SUBJECT: Forwards addl info in order to complete review of App J
 submittals. Info provides addl justification in support of
 submittals.

Re: Oconee Nuclear Station
Docket Nos 50-269, -270, -287

Attachment 1

Duke Power Company
Oconee Nuclear Station

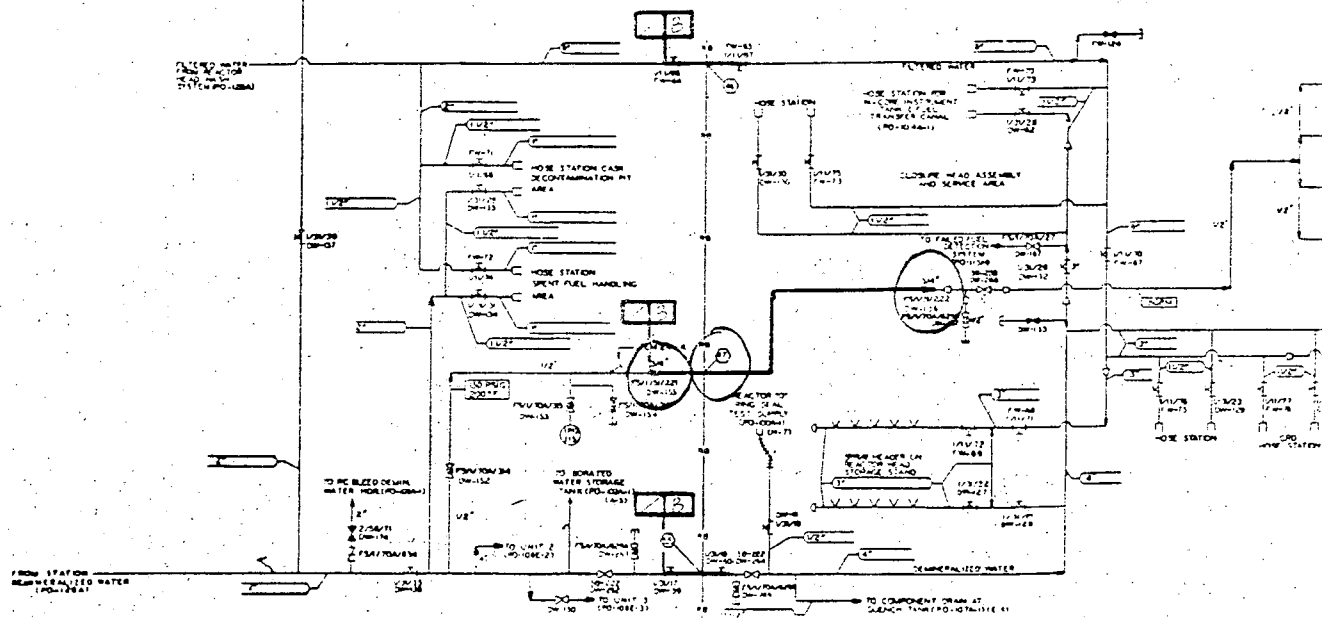
With regard to Penetration 47 (Unit 1 only), Demineralized Water Supply to RC Pump Seal Vents, the Staff and consultant disagree with the Duke statement that Type C testing is not required because the valves do not perform a containment isolation function. The basis for the Staff's position is provided in the following:

Generally, Type A testing is not an adequate substitute for Type C testing for two reasons:

1. Type C testing is performed twice as often as Type A testing.
2. Type C testing tests valves individually while Type A testing tests penetrations (i.e., two shut valves in series). This is necessary to ensure that in the case where one isolation valve fails to shut following an accident, the penetration is adequately isolated. Type A testing is insufficient for this purpose since the leak-tightness of the penetration is established by the more leak-tight of the two shut valves.

In view of the foregoing, our consultant finds that Type C testing of these valves is required. We concur with our consultant's conclusion that the isolation valves of the Demineralized Water Supply to the RC Pump Seal Vents conform to the Type C test requirements.

Attached is a piping diagram of the area of concern. Both the inside and outside valves are tilting disc check valves. This line supplies a small amount (2GPH) of demineralized water to rinse off borated water seepage through the RC pump seals to prevent boron crystal buildup. This system is drained and vented during a Type A test. The piping from valve DW-156 to the RC pumps is postulated to rupture in the event of a loss-of-coolant accident. It is considered to be a low likelihood event that the inside valve will fail to close and fully seat. The tilt-disc design tends to aid closure; the force of any pressure buildup within the containment would tend to aid closure; and finally, the purity of the water involved tends to eliminate any concern about failure of the check valve to function properly.

During the 1980 refueling outage of Oconee 1, this penetration was hydrostatically tested by pressurizing the piping downstream of DW-156. The measured leakage was less than 2×10^{-4} wt %/day, well within the allowable.

Based on the above, it is not considered necessary that the penetration be modified to allow Type C leak testing to be performed. Nevertheless, the penetration will be suitably modified to allow Type C leakage testing.

CORE FLOODING SYSTEM

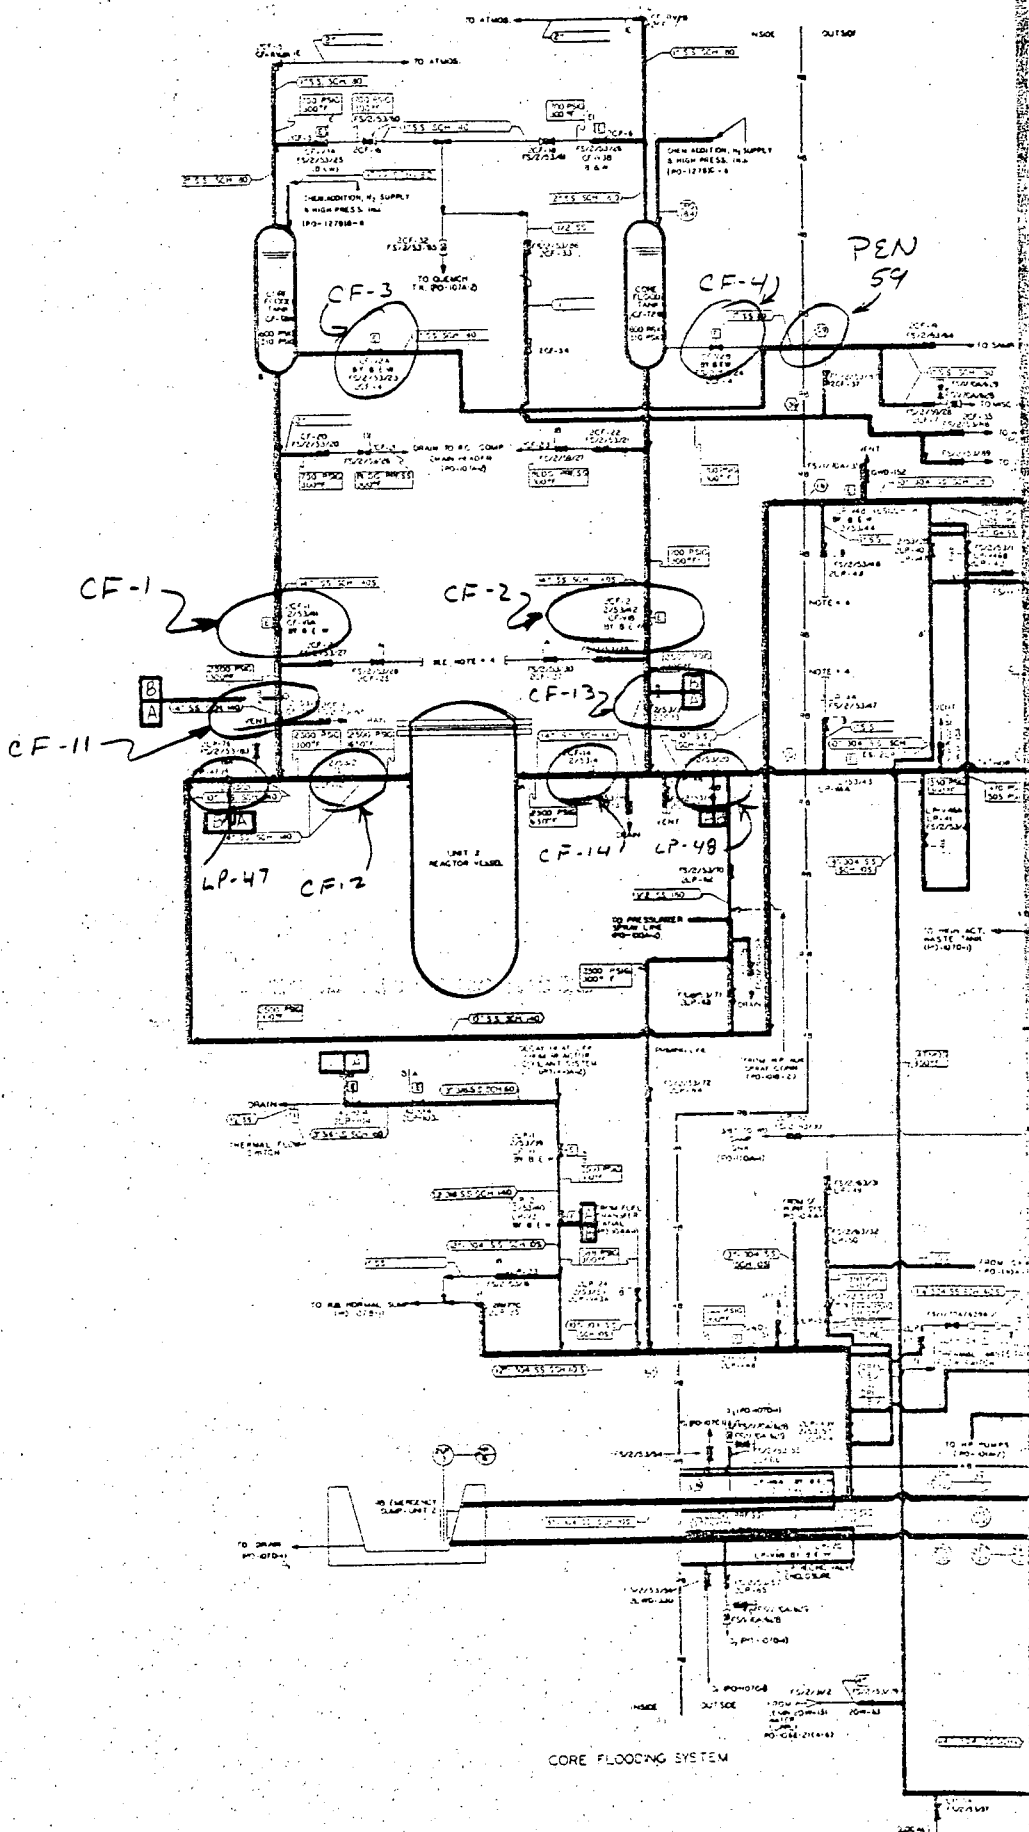
With regard to Penetration 59, Core Flood Tank Sample Line, the Staff and consultant disagree with the Duke statement that Type C testing is not required because the valves do not perform a containment isolation function. This basis for the Staff's position is provided in the following:

Core Flood Tank (CFT) sample isolation valves can become a barrier to the escape of containment air in the case where the LOCA break is located such that the contents of a tank are discharged into the containment. In this case, a leaking sample line will allow the CFT nitrogen to be vented such that containment atmosphere can then enter the CFT by leaking through check valve CF-11 or CF-13. Since these valves may be relied upon to prevent the escape of containment air in this situation, we and our consultant conclude that Type C testing of the core flood tank line valves is required.

Attached is a piping diagram of the area of concern. Pertinent valve numbers have been highlighted as has Penetration 59. For a postulated break between valves CF-11(-13), CF-12(-14) and LP-47(-48), a core flood tank would depressurize to containment but it would most likely not be a LOCA. Check valves CF-12 and -14 tend to seat with RC pressure and would prevent any loss of coolant from occurring. They are also periodically leak checked pursuant to Technical Specifications 3.1.6.10 and 4.5.1.2.3. If the break is postulated to continue, operators would isolate the affected Core Flood Tank (CFT) by closing CF-1, -2 when directed by procedure. With a CFT isolated, a unit shutdown would then be required by Specifications 3.0 and 3.3.

If the break were postulated to occur between CF-12(-14) and the reactor vessel, a LOCA would occur and the CFTs would depressurize and Low Pressure Injection would be initiated. As the Reactor Coolant System is depressurized, coolant would flow out the break and make-up would be provided by ECC systems. In all cases it is predicted that ambient pressure in the containment is less than, or at most, equal to system pressure. Furthermore, by the design of the system, this piping is low in the containment relative to the entry point in the vessel. CF-12, -14 are located in vertical runs of piping, just prior to entry into the Reactor Vessel. Also, operators are directed to isolate the depressurized CFTs by closing CF-1, -2. Regardless of where the break is, cooling water would tend to seat CF-11, -13. Thus, regardless of break location, it is not credible to conclude that the CF Tank Sample isolation valves will ever see containment atmosphere following a postulated break that discharges the content of a tank into the containment.

Based on the above, it continues to be our position that a Type C test need not be performed on this Penetration.
